# Communication to Planning Commission

Re: Amendment to Autozone Brickyard Planned Development (#410-08-39)

The Boyer Company proposes to amend the recently approved Autozone Brickyard Planned Development (410-08-39) in order to install a monument sign for the project.

**Attachment 'A'**  
Photographs

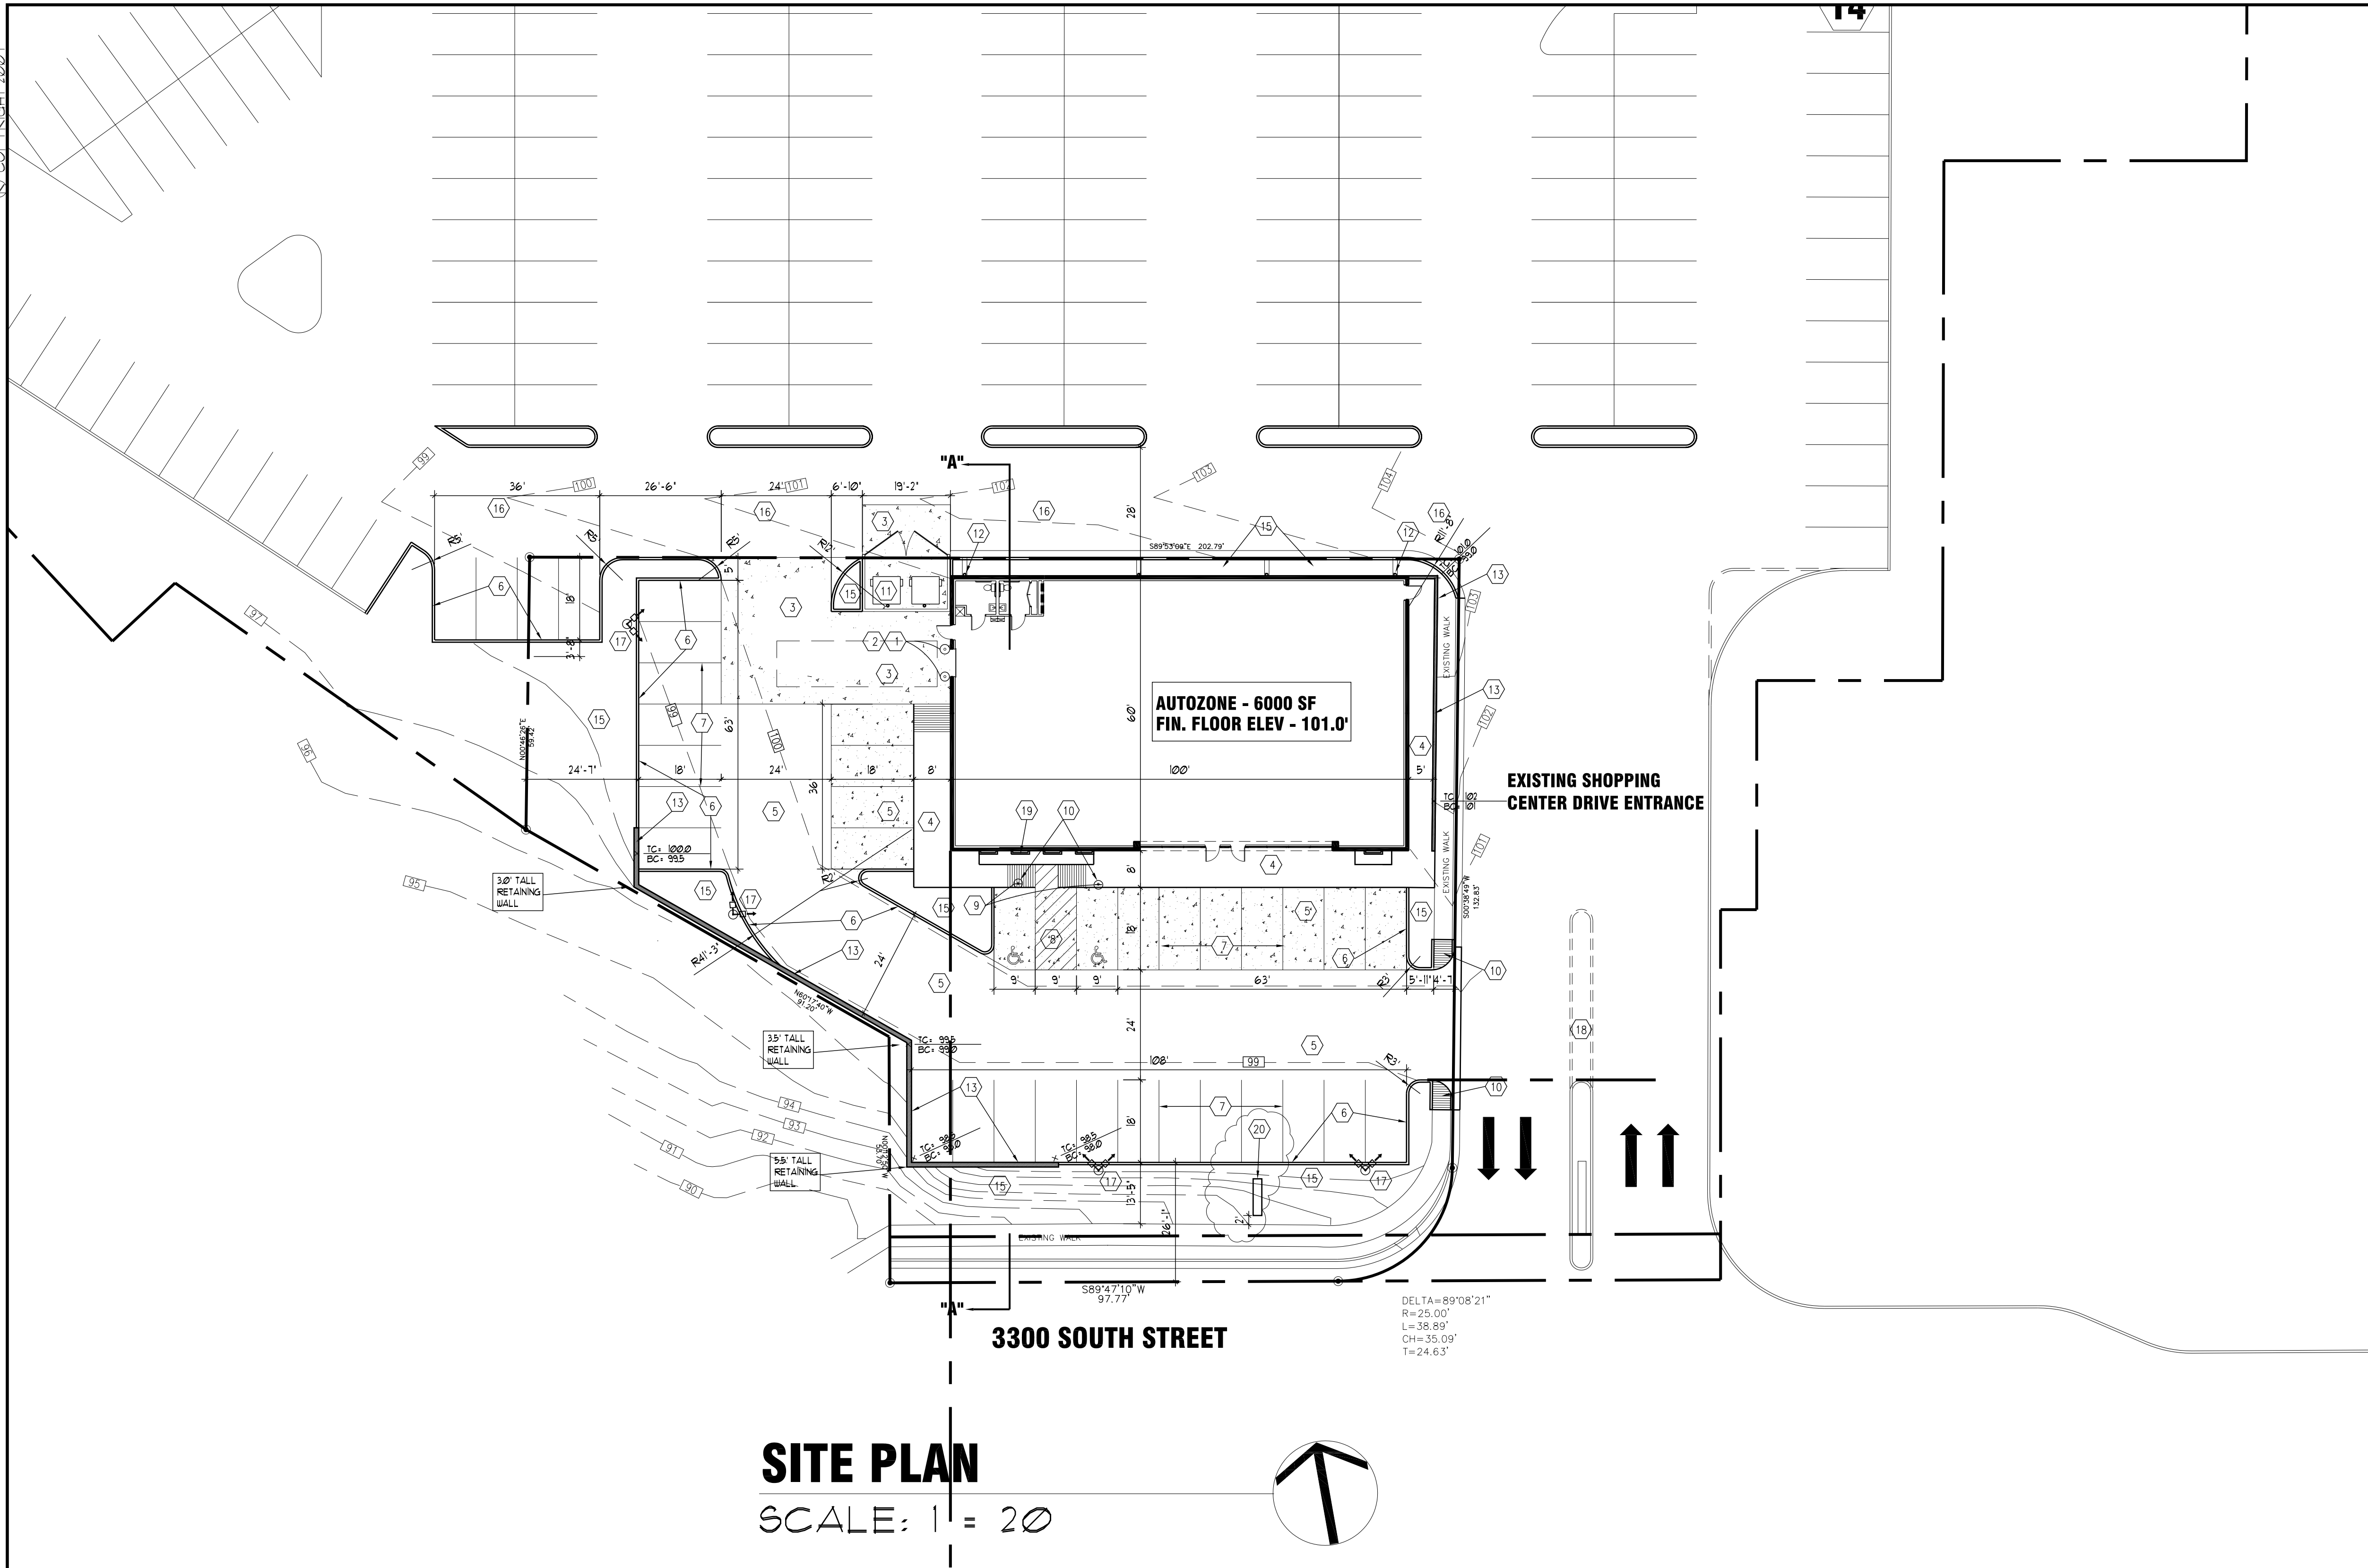
The proposed sign complies with all dimensional limits for monument signs in the CB district. The only regulation it does not comply with is the number of signs allowed per street frontage for a project. In reviewing the past report for the original planned development (410-08-39) the “pad site” was treated as its own parcel with respect to landscaping and parking ordinances. The same could be applied to signs for this pad site. The pad site appears to function as its own site.

As part of the original planned development the proposed building was approved for a location 92 feet back from the front property line along 3300 South. The proposed sign would be located 14 feet from the front property line. The existing pole sign is located 10 feet from the front property line and 68 feet due east from the proposed sign. The existing pole sign’s height and closer proximity to the street arguably make it more visible than the proposed monument sign.

Staff is of the opinion that the new retail use should utilize the existing pole sign shared by some of the other businesses of the Brickyard Plaza center, thereby preventing further visual sign clutter along 3300 South. Staff concurs that this pad site is somewhat separated from the larger Brickyard center and understands the applicant’s desire for an additional sign but staff finds no justification for the extra sign.

**SITE PLAN**  
SCALE: 1" = 20'

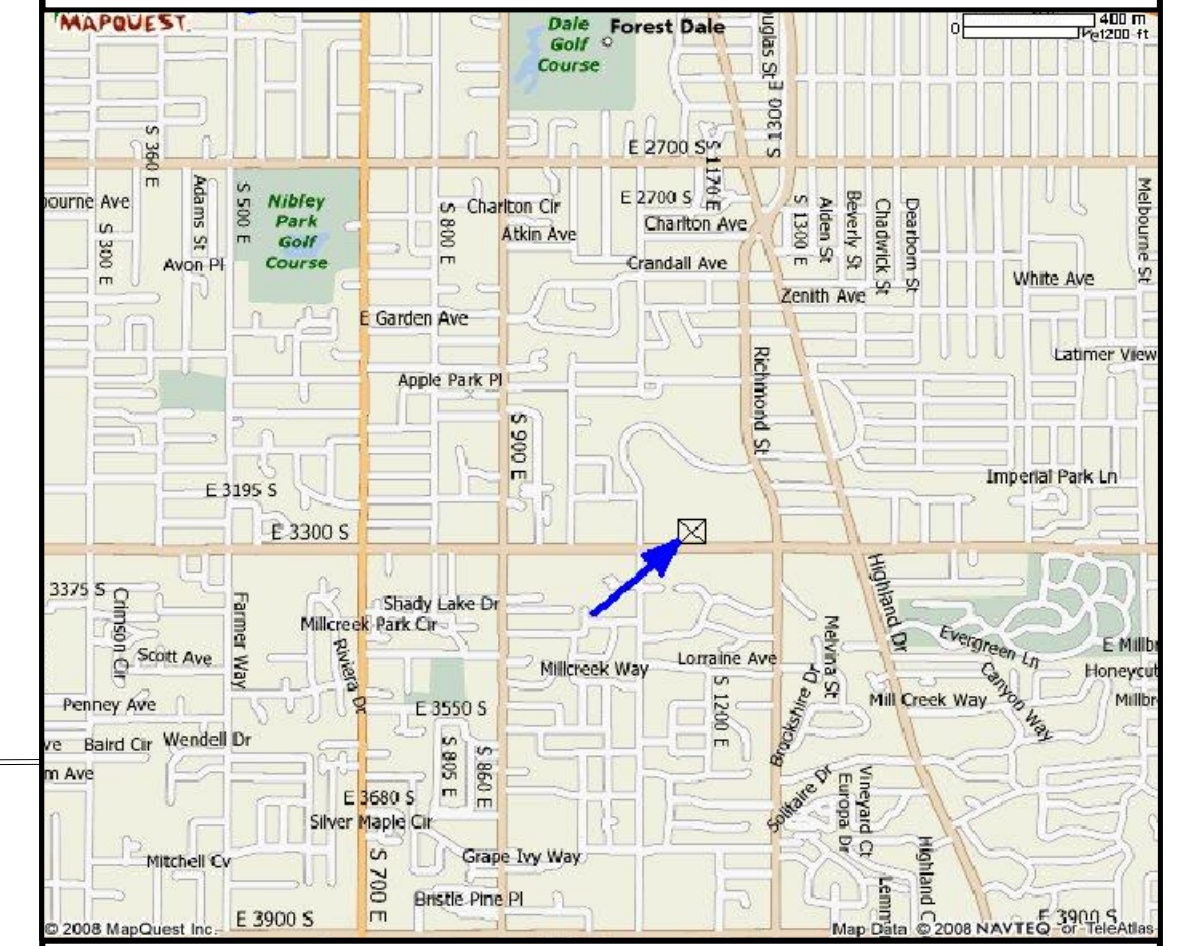
- **Public Utilities:** No comments.
- **Engineering:** No comments.
- **Transportation (Barry Walsh):** “The sign location shown presents no impact to the required vehicular clear sight distance zone for the driveway access to 3300 South and does not encroach within the public right of way or the pedestrian sidewalk corridor.”
- **Fire (Ted Itchon):** No comments.
- **Building Services:** No comments.
